### **Project: IEEE P802.15 Working Group for Wireless Personal Area Networks (WPANs)**

Submission Title: [comment CID 12 and proposed resolution]

Abstract: [Proposed resolution about comment CID 12 ]

Rgure D 1—Hopping pattern a∎∎ignment

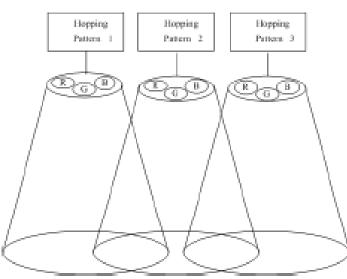
- 1. Pleaser refer following instruction
- Delete figure Figure D.1—Hopping pattern assignment and Table D.2—Example of hopping pattern assignment at line 21 page 276
